Access Compliance Report

Public Rights-of-Way

Intersection ID: 26208	Main Street: BALLANTRAE VILLAGE DR	Cross Street: ELM LN	Location: NE
ADA ID: 5783A4BF2319	Ramp Type: MedianPerp	Initial Pass/Fail: Fail	Overall Compliance: No
Severity Score: 33.75			
Codes/Mitigation Info/Possible Solution		Field Measurements/Component Compliance

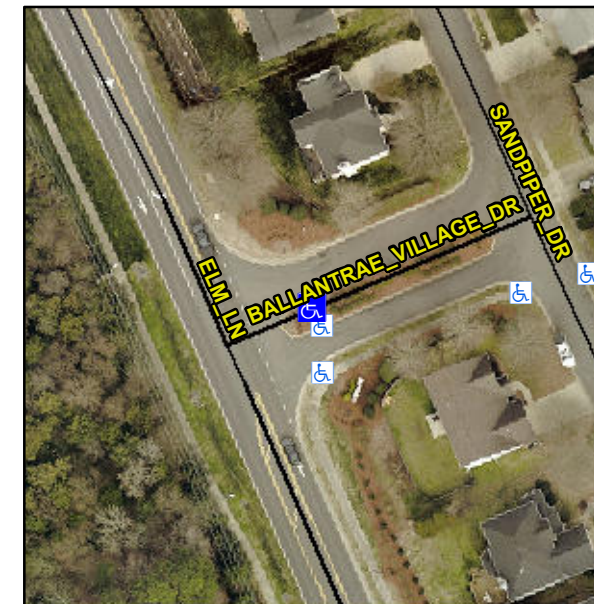
Not Found, R304.5.1, R304.2.2, R304.5.3

Compliance	Description	Data	Compliance	Description	Data
N/A	Ramp Length (in)	70.0	No	Ramp Slope (%)	10.0
No	Ramp Width (in)	44.5	No	Ramp XSlope (%)	6.8
N/A	Flare Type LT	N/A	N/A	Flare Type RT	N/A
N/A	Flare Slope LT (%)	N/A	N/A	Flare Slope RT (%)	N/A
N/A	Flare Traversable LT?	N/A	N/A	Flare Traversable RT?	N/A
N/A	Landing Length (in)	N/A	N/A	DWS Provided?	N/A
N/A	Landing Width (in)	N/A	N/A	DWS Contrast?	N/A
N/A	Landing Slope (%)	N/A	N/A	DWS Length (in)	N/A
N/A	Landing X Slope (%)	N/A	N/A	DWS Full Width?	N/A
N/A	Landing Curb? (Y/N)	N/A	N/A	DWS Offset (in)	N/A
N/A	Shared Landing?	N/A			
N/A	Gutter Ponding?	N/A	N/A	Gutter Slope (%)	N/A
N/A	Gutter Lip Ht (in)	N/A	N/A	Gutter X Slope (%)	N/A
N/A	Painted X Walk1?	No	N/A	Painted X Walk2?	N/A
	X Walk 1 Direction	To N		X Walk 2 Direction	N/A
N/A	X Walk 1 Width (in)	N/A	N/A	X Walk 2 Width (in)	N/A
	X Walk 1 Slope (%)	0.8		X Walk 2 Slope (%)	N/A
	X Walk 1 X Slope (%)	7.5		X Walk 2 X Slope (%)	N/A

Remove & Replace Entire Ramp.
